Project	IEEE 802.16 Broadband Wireless Access Working Group < http://ieee802.org/16 >	
Title	A MAP IE for H-ARQ and SDMA Allocation in AAS Zone	
Date Submitted	2005-01-1825	
Source(s)	InSeok Hwang, Jaehee Cho, Seungj Maeng, JangHoon Yang, Hoon Huh, SangHoon Sung, Jaeho Jeon, Soonyoung Yoon Samsung Electronics, Inc.	is91.hwang@samsung.com
	Ran Yaniv, Tal Kaitz Alvarion Ltd.	ran.yaniv@alvarion.com
	Dave Pechner, Doug Dahlby, Todd Chauvin ArrayComm Inc.	dpechner@arraycomm.com
Re:	Call for reply comments (Original Comment # 2189)	
Abstract	A new efficient Normal MAP IE supporting for Hybrid ARQ and SDMA allocation in AAS zone is proposed.	
Purpose	Adoption in IEEE 802.16e_D6	
Notice	This document has been prepared to assist IEEE 802.16. It is offered as a basis for discussion and is not binding on the contributing individual(s) or organization(s). The material in this document is subject to change in form and content after further study. The contributor(s) reserve(s) the right to add, amend or withdraw material contained herein.

A MAP IE for H-ARQ and SDMA Allocation in AAS Zone

Fig. 1. Proposed SDMA Allocation Scenario

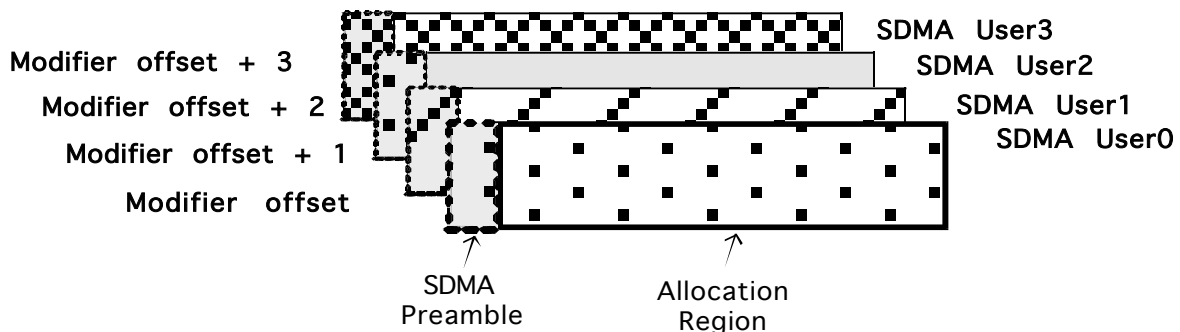
The burst allocation region of SDMA users can be fixed for scheduling simplicity and lower signaling overhead. In addition, modifier index for SDMA preamble can be extracted from description order of SDMA users. The proposed solution can be summarized as follows

- 1) Introduce Extended IUC in DL/UL MAP for SDMA allocation (not available yet)
- 2) Use '1' of '5' reserved bits in AAS_IE() to specify modifier type, "Time" or "Freq." shift
- 3) Describe the shared 2D (DL) or 1D (UL) allocation regions

- Specify {CID, modulation/coding schemes (IUC or H-ARQ)} fields
 - ~~Implicitly assign SDMA preamble index with description order of CIDs. Due to limited length of Extended IUC, starting offset of preamble modifier is included.~~
 - Optionally include CQICH/ACKCH allocation IE for DL burst and uplink power adjustment IE.
 - **Optionally specify pilot patterns for SDMA users**
- 4) Use a pointer IE for special Sub Map including the all information elements described above.

Figure XXX – Pilot patterns for AAS mode in AMC zone. Symbol offset is relative to the beginning of the zone. Pilot polarity for each pattern is given in brackets.

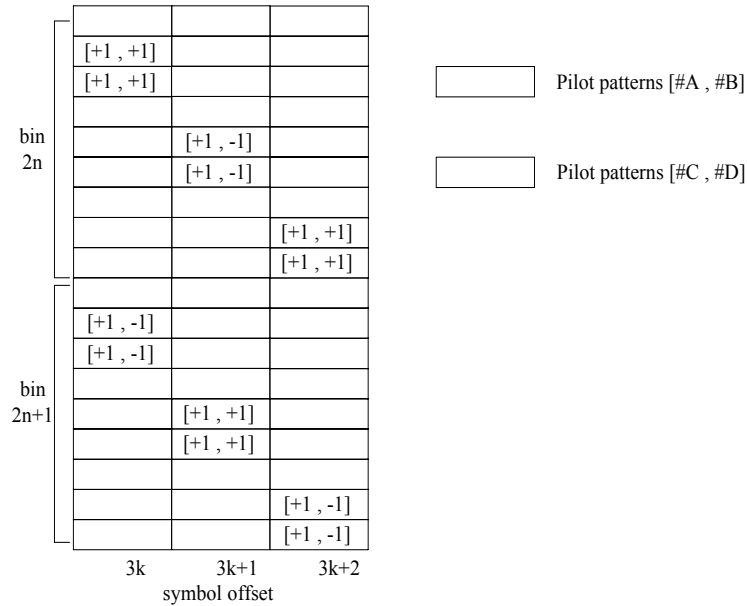
The pilots in an AMC AAS zone are regarded as part of the allocation, and as such shall be beamformed in a way that is consistent with the transmission of the allocation's data subcarriers. In an SDMA region, the pilots of each allocation may correspond to a different pilot pattern. A pilot pattern consists of location and polarity. The pilot patterns are depicted in figure XXX. Data subcarriers shall be punctured to obtain patterns #2 and #3. Subcarriers shall only be punctured if there is an allocation associated with the corresponding pattern, as described in the AAS_SDMA_DL_IE() and AAS_SDMA_UL_IE(). Only MSSs that support all four pilot patterns, as indicated by their capability in 11.8.3.7.X, shall be assigned allocations in an SDMA region where pilot patterns #2 and #3 are used. Data subcarriers shall be punctured after constellation mapping in the case of CC encoding, and prior to constellation mapping in the case of CTC encoding. In the latter case, the FEC block shall be truncated to accommodate the punctured subchannel structure, and the data subcarrier enumeration of Eq. (116) shall not be applied. Instead, data subcarriers within a slot shall be enumerated starting from the first OFDMA symbol at the data subcarrier that is lowest in frequency, continuing in ascending frequency order throughout the slot's subcarriers in the same symbol, then going to the next symbol at the subcarrier lowest in frequency, and so on.
